REPORT TO COMMON COUNCIL

Item: Preliminary Plat - Third Addition to Clearwater Creek

Subject: Third Addition to Clearwater Creek - Submittal No. 1

2020 EROSION & SEDIMENT CONTROL PLAN REVIEW CHECKLIST

PRELIMINARY PLAT
THIRD ADDITION TO CLEARWATER CREEK

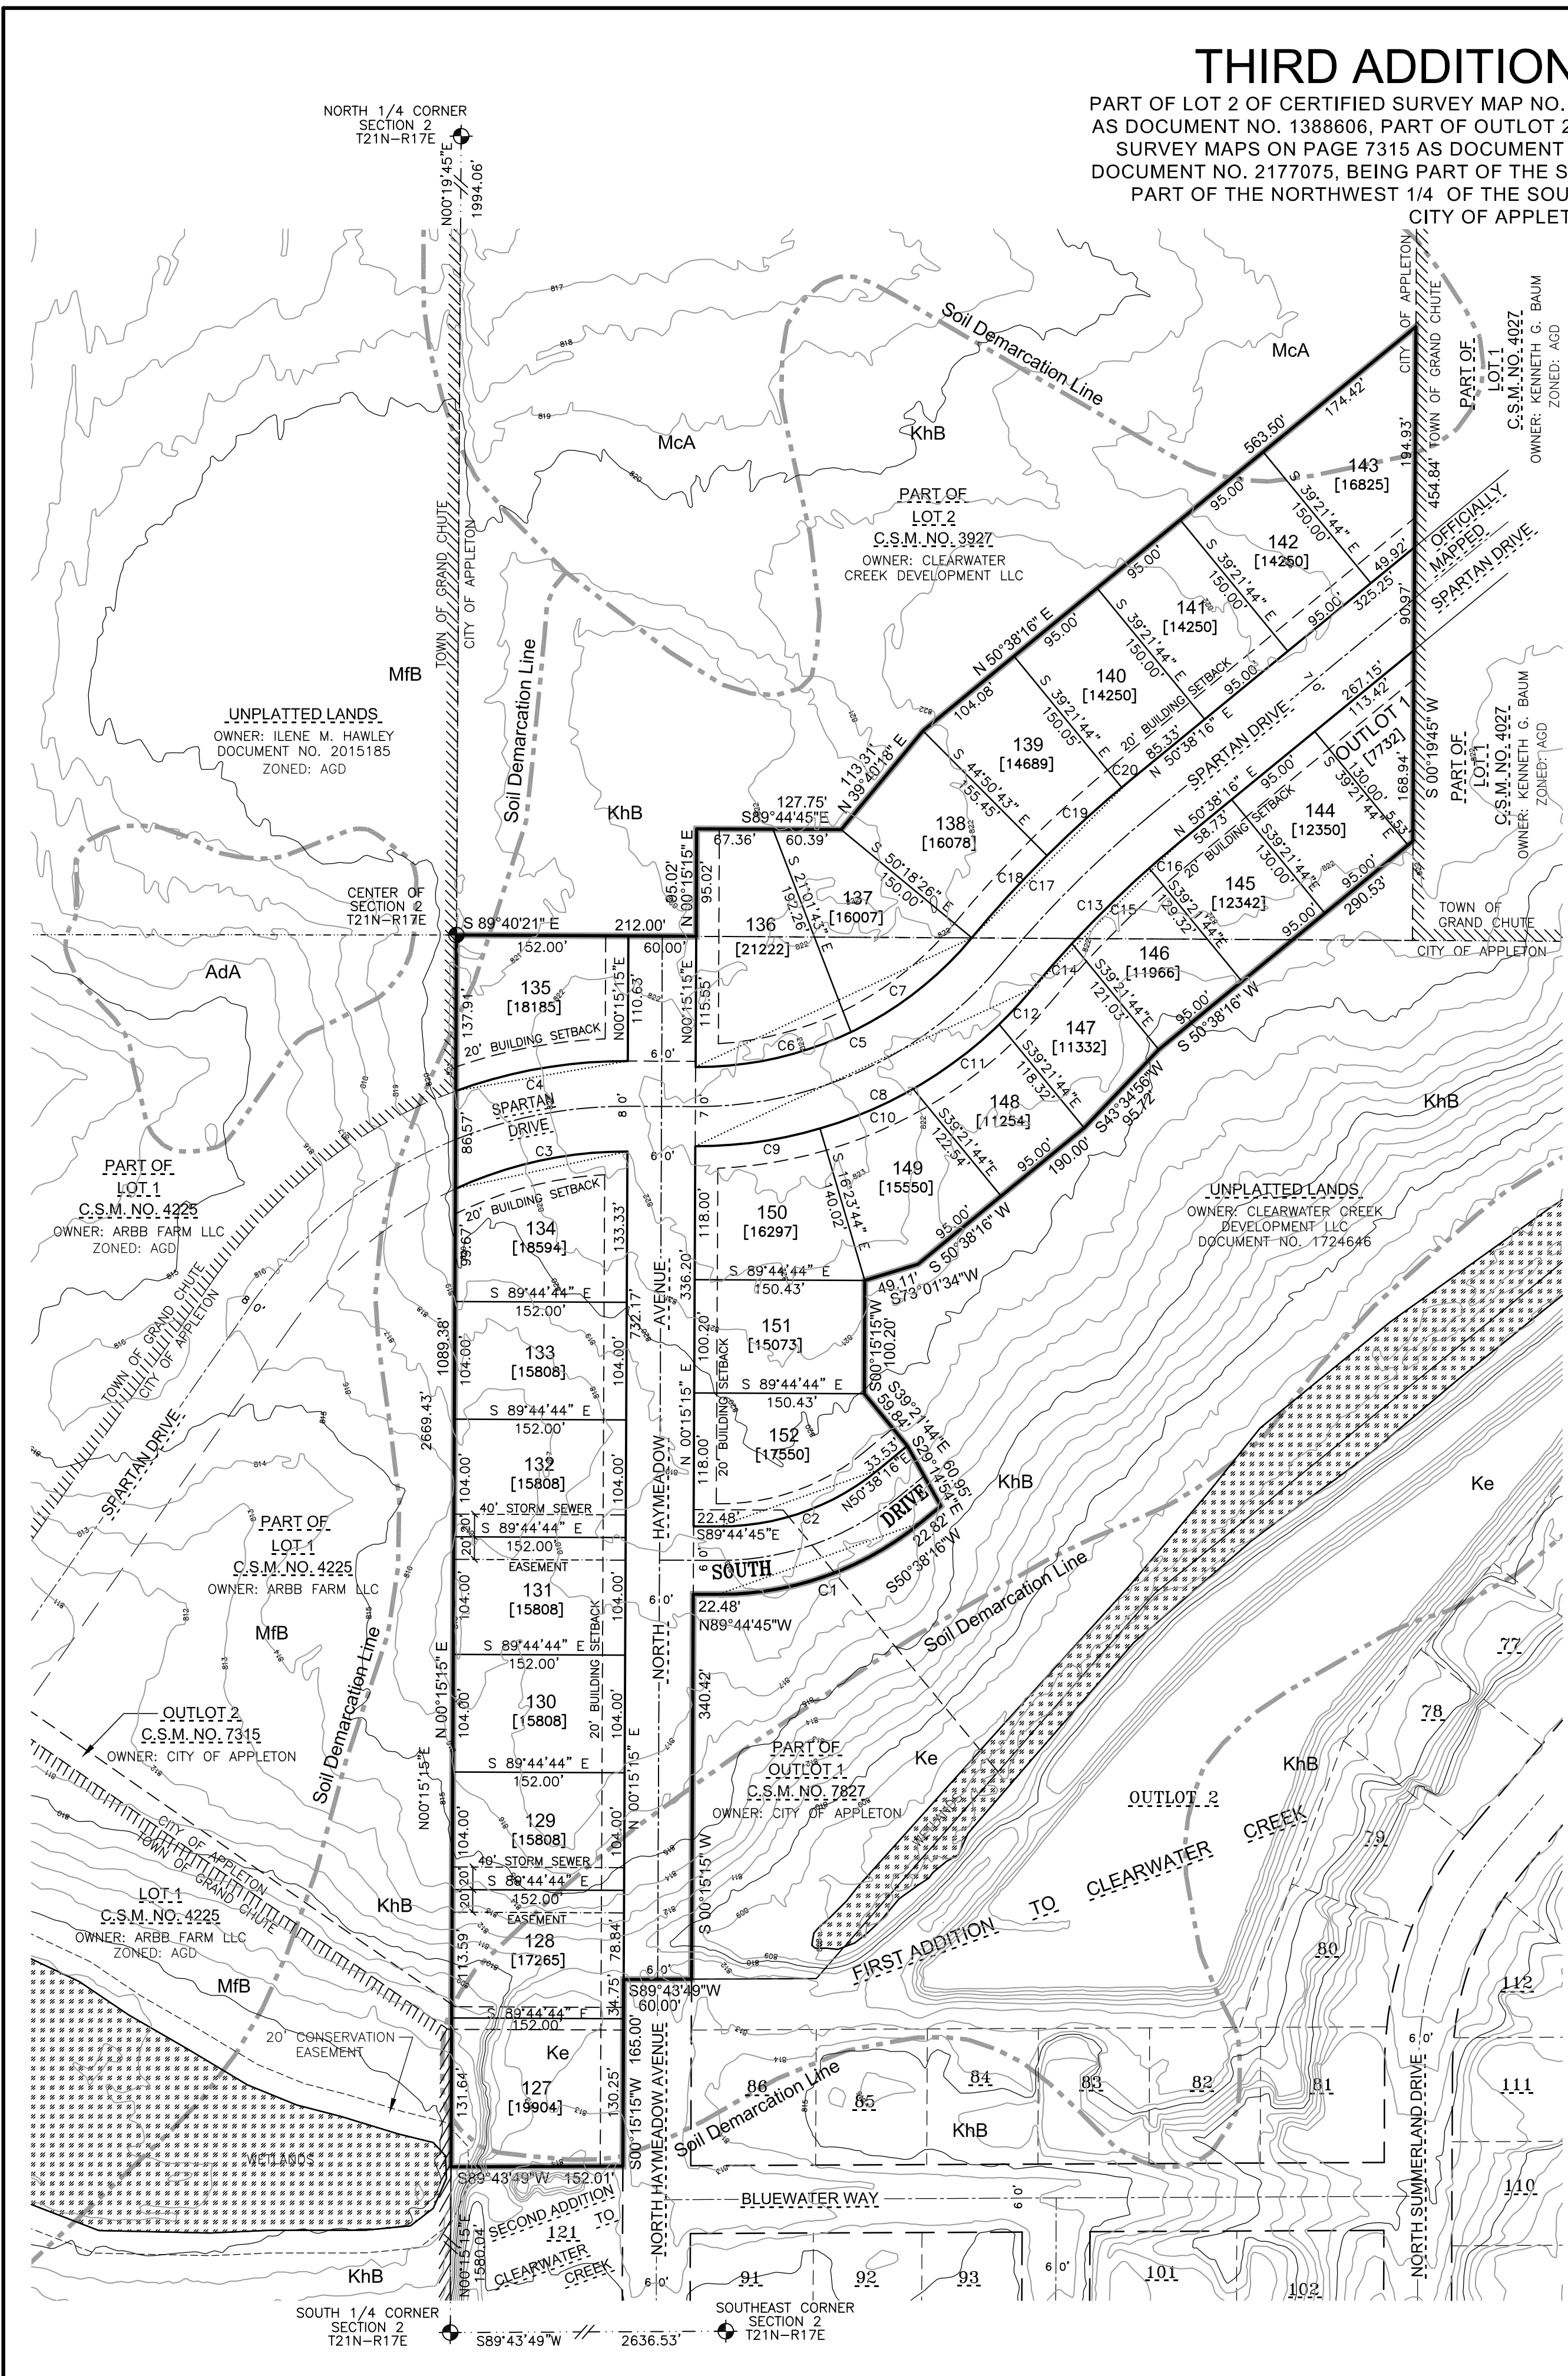
4. There is currently a 20-foot wide parcel of City-owned land that runs between proposed Lots 127 and 128. Prior to any transfer of land, a sanitary sewer easement will be required across this entire area.

6. Add the following note to the area directly west of the subject area to the Final Plat.
 - *Future Business/Industrial Uses per the City of Appleton's Comprehensive Plan 2010-2030 Future Land Use Map*

8. The final plat boundary should reflect the fact that portions of Haymeadow Avenue and Spartan Drive have previously been dedicated by C.S.M.

9. The listed benchmarks match the City of Appleton records on 29 datum not 88 datum, revise as necessary.
10. Street name “South” is not an acceptable street name per the City of Appleton Street Name Standards. Propose an alternate street name for proposed South Drive on the Final Plat.

11. Identify the purpose of Outlot 1 on the Final Plat.
12. The owner/applicant shall submit to the City the Final Plat within 36 months after the last required approval of the Preliminary Plat. If the Final Plat is not submitted within said 36 months, the City (and any other approving authority) may refuse to approve the Final Plat and shall recommence the procedure for Preliminary Plat approval or may extend the time for submission of the Final Plat.
